Range SA Large Regional - Ho.Re.Ca.	Model 9100 – 9000 – 95 – Krea Touch	N° T.I. 04_2024
Serial Number See page 2 / 2	Subject NEW PISTON ASSEMBLY Z4000 ES/FB

New ESFB Z4000 **welded** piston assembly + three O-Rings

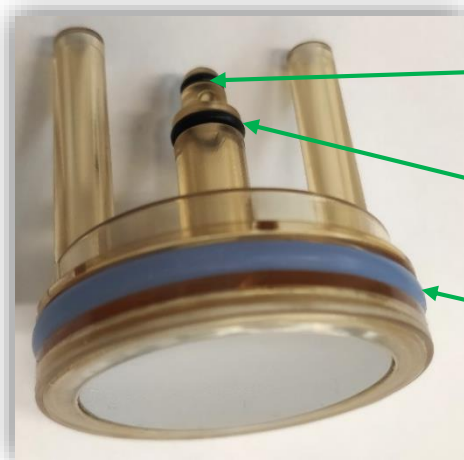
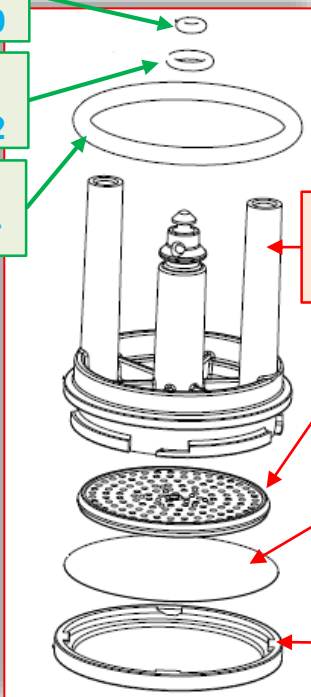
Pre – modified ES/FB Z4000 **upper piston** assembly has been replaced by **new** "ESFB Z4000 **welded** piston assembly + three O-Rings".

For the **new upper piston** assembly the filter is welded to the piston.

This ensures that the filter lasts for a greater number of strokes.

Spare code: **266009**

The **three O-Rings 1, 2, 3** can be ordered individually

- OR 1**
Code: **254650**
- OR 2**
Code: **0V0782**
- OR 3**
Code: **251757**
